CONVERSATION RECORD

James Botti, MS, proposed RSO for St. John Macomb Hospital

License No.: 21-01190-05

Control No.: 314270

FACILITY DIAGRAM

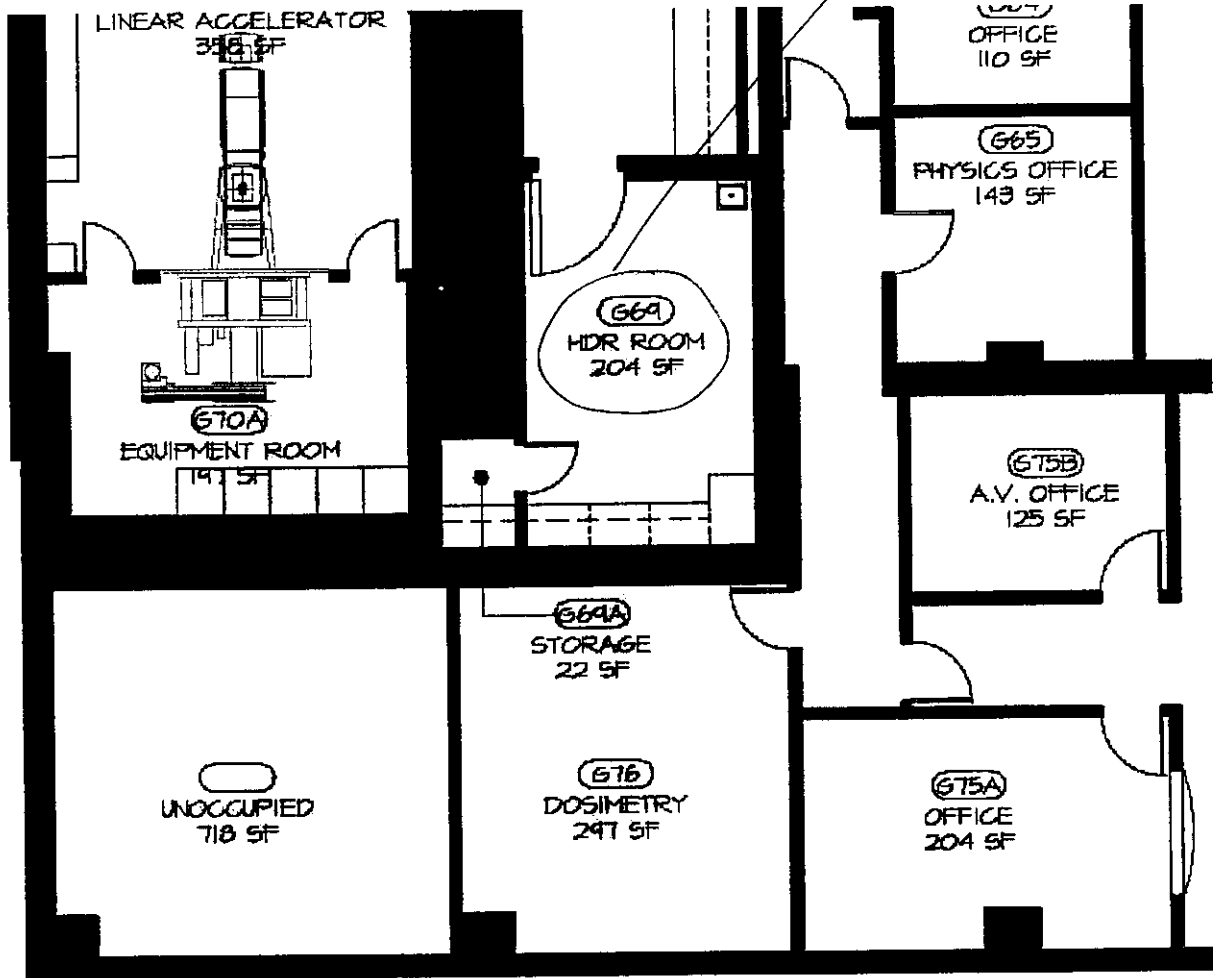
7. Item 8.15, Item 9 of your renewal application dated March 10, 2005, shows a facility diagram, including a room labelled "HDR room," marked G69. Your license does not authorize a HDR device. **Please explain this room marking.**

Preventative notation on diagram
